**Agenda item:** 3  
**Source:** Motorola  
**Title:** Text proposals for Closed loop transmit diversity mode 2 to TS.25.214  
**Document for:** Approval

The whole chapter 8.3 of TS 25.214 v1.3.1 is proposed to be replaced with the following text:

**Figure 1. Progressive Refinement at the UE for closed loop mode 2.**

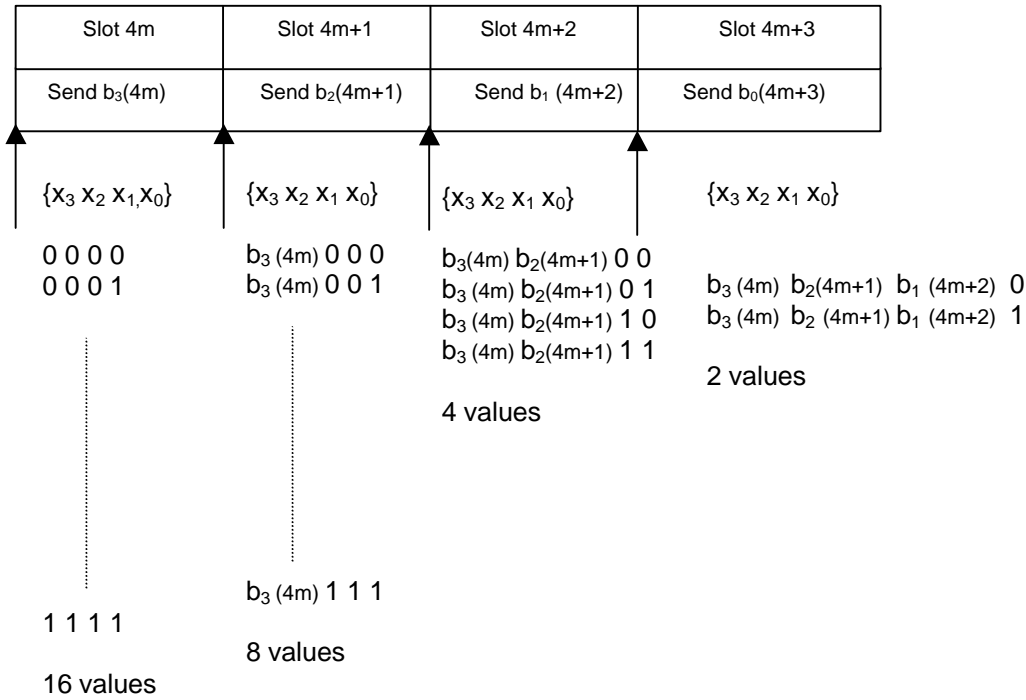
To obtain the best performance, progressive updating is performed at both the UE and the UTRAN Access point. Every slot time, the UE refines its choice of FSM, from the set of weights allowed given the previously transmitted bits of the FSM. This is shown in Figure 1, where, in this figure b<sub>i</sub> (0<i<3) are the bits of the FSM (from Table 1 and Table 2) from the MSB to the LSB and m=0, 1, 2, 3 (the end of frame adjustment given section 8.3.1 is not shown here).

At the beginning of a FSM to be transmitted, the UE chooses the best FSM out of the 16 possibilities. Then the UE starts sending the FSM bits from the MSB to the LSB in the portion of FBI field of the uplink DPCCH during 4 (FSM message length) slots. Within the transmission of the FSM the UE refines its choice of FSM. This is defined in the following. :

Define the 4 bits of FSM, which are transmitted from slot number k to k+3, as {b<sub>3</sub>(k) b<sub>2</sub>(k+1) b<sub>1</sub>(k+2) b<sub>0</sub>(k+3)}, where k=0, 4, 8, 12. Define also the estimated received power criteria defined in Equation 1 for a given FSM as p({x<sub>3</sub> x<sub>2</sub> x<sub>1</sub> x<sub>0</sub>}), where {x<sub>3</sub> x<sub>2</sub> x<sub>1</sub> x<sub>0</sub>} is one of the 16 possible FSMs which defines an applied phase and amplitude offset according to Table 1 and Table 2. The b<sub>i</sub>() and x<sub>i</sub> are 0 or 1.

The bits transmitted during the m'th FSM of the frame, where m=0,1,2,3, are then given by

b<sub>3</sub>(4m)=X<sub>3</sub> from the {X<sub>3</sub> X<sub>2</sub> X<sub>1</sub> X<sub>0</sub>} which maximises p({x<sub>3</sub> x<sub>2</sub> x<sub>1</sub> x<sub>0</sub>}) over all x<sub>3</sub>,x<sub>2</sub>,x<sub>1</sub>,x<sub>0</sub> (16 possible combinations);

$b_2(4m+1)=X_2$  from the  $\{b_3(4m) X_2 X_1 X_0\}$  which maximises  $p(\{b_3(4m) x_2 x_1 x_0\})$  over all  $x_2, x_1, x_0$  (8 possible combinations);  
 $b_1(4m+2)=X_1$  from the  $\{b_3(4m) b_2(4m+1) X_1 X_0\}$  which maximises  $p(\{b_3(4m) b_2(4m+1) x_1 x_0\})$  over all  $x_1, x_0$  (4 possible combinations);  
 $b_0(4m+3)=X_0$  from the  $\{b_3(4m) b_2(4m+1) b_1(4m+2) X_0\}$  which maximises  $p(\{b_3(4m) b_2(4m+1) b_1(4m+2) x_0\})$  over  $x_0$  (2 possible combinations).
